**STAFF RECOMMENDATION**  
**1702 Sweetbriar Avenue**  
**December 21, 2016**

**Application:** New construction- outbuilding; Setback determination  
**District:** Belmont-Hillsboro Neighborhood Conservation Zoning Overlay  
**Council District:** 18  
**Map and Parcel Number:** 11704001300  
**Applicant:** Tyler Lemarinel, Allard Ward Architects  
**Project Lead:** Paul Hoffman, paul.hoffman@nashville.gov

1 Site Layout Plan Scale: 1/16"=1'-0"

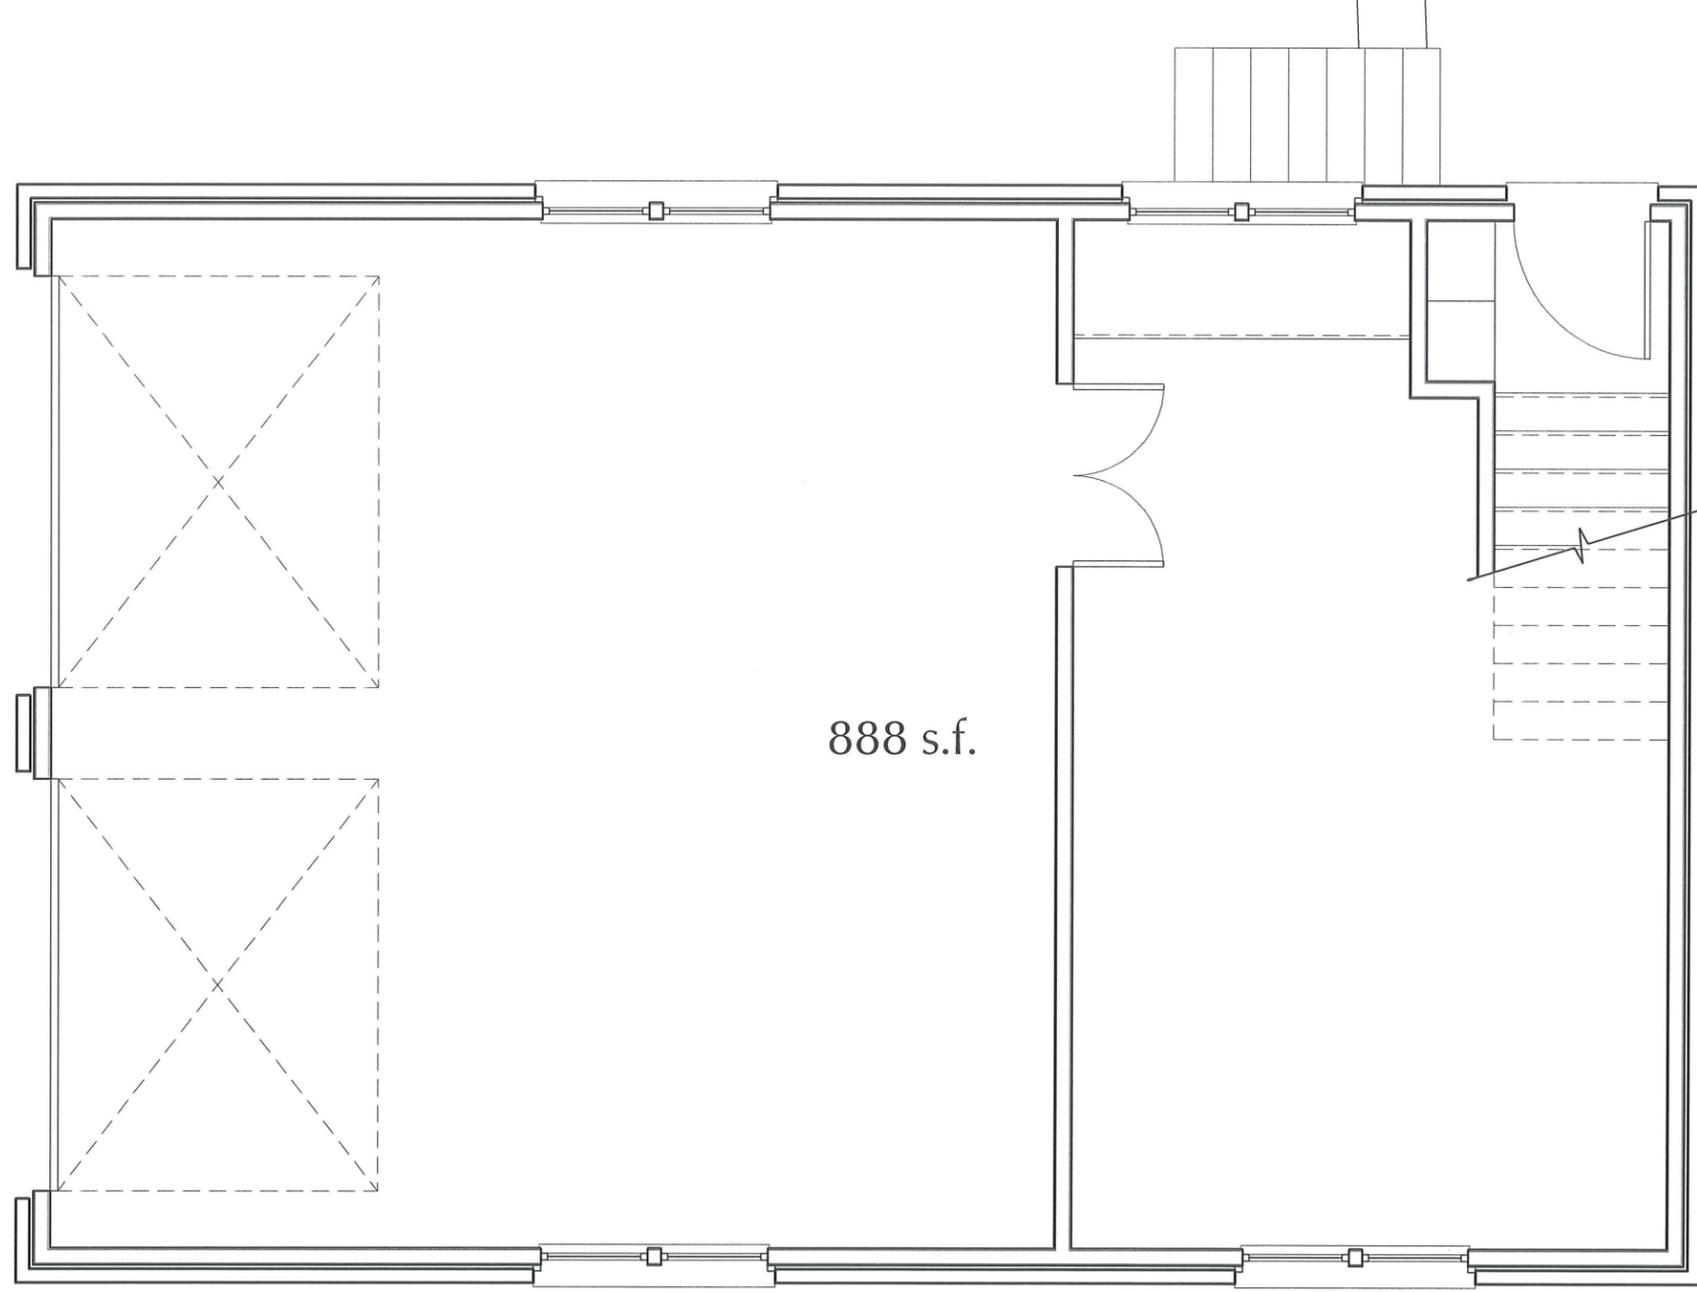
Setbacks: When an outbuilding has a footprint greater than seven hundred square feet (700 sq. ft.), bulk zoning requires that the structure be located twenty feet (20') from the rear property line, and five feet (5') from the sides. The new outbuilding has a footprint of eight hundred and eighty-eight square feet (888 sq. ft.). It is proposed four feet, four inches (4' 4") from the rear and three feet, two inches (3' 2") from the right side property

line. Staff finds that the proposed rear setback is appropriate since historically, outbuildings were located at the rear of the property, close to the rear property line. Staff finds the location appropriate and recommends approval of the setback determination. The project meets Section II.B.i. of the design guidelines.

<b>MINIMUM</b>	<b>PROPOSED</b>
<b>Space between principal building and outbuilding</b>	20’	20’
<b>Rear setback</b>	20’	4’4”
<b>L side setback</b>	5’	43’
<b>R side setback</b>	5’	3’ 2”
<b>How is the building accessed?</b>	From the alley or existing curb cut	Alley
